UNITED STATES
DEPARTMENT OF THE INTERIOR
BUREAU OF LAND MANAGEMENT

SUNDRY NOTICES AND REPORTS ON WELLS
Do not use this form for proposals to drill or to re-enter an abandoned well. Use form 3160-3 (APD) for such proposals.

8. Well Name and No.
TURNER B 371. Type of Well
☒ Oil Well ☐ Gas Well ☐ Other2. Name of Operator
LINN OPERATING, LLCContact: DEBI GORDON
E-Mail: dgordon@linnenergy.com9. API Well No.
30-015-051933a. Address
600 TRAVIS ST. SUITE 1400
HOUSTON, TX 770023b. Phone No. (include area code)
Ph: 281-840-4010
Fx: 832-209-434010. Field and Pool or Exploratory Area
GRAYBURG JACKSON;SR-Q-G-S4. Location of Well (Footage, Sec., T., R., M., or Survey Description)
Sec 17 T17S R31E Mer 6PM SWSW 330FSL 990FEL11. County or Parish, State
EDDY COUNTY, NM

PROPOSED PLUG & ABANDONMENT PROCEDURE

PROPOSED P&A

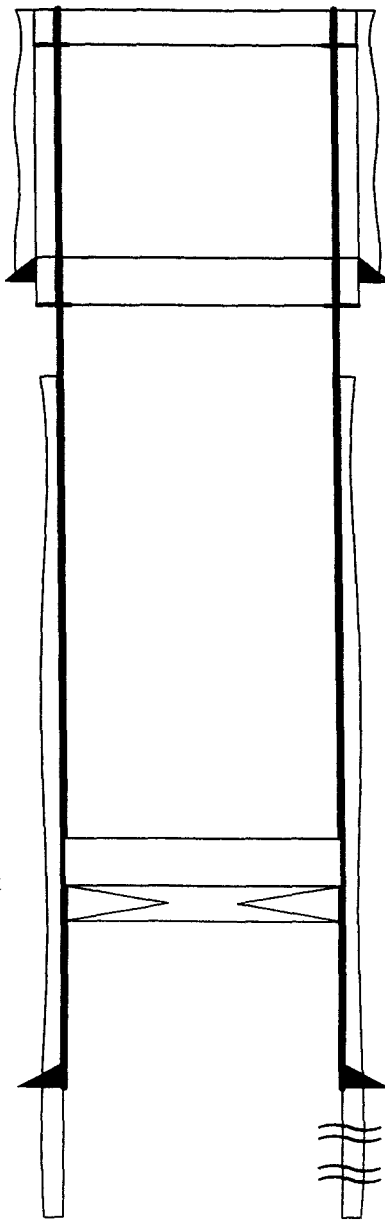
Below ground level dry hole marker required

1. RIH w/ tbg to PBTD @ 1750'
2. Circ well w/ MLF, POOH *Perf @ 1314. 502 cmt to 1214 (B/salt) woc*
3. Perf @ 583' & Sqz, leave cmt inside prod csg f/ 483'-583', WOC & Tag *445 (shoe/T salt)*
4. Perf @ 100' & Sqz, leave cmt inside prod csg f/ Surf-100'
5. Cut off wellhead, weld on below ground dry hole marker
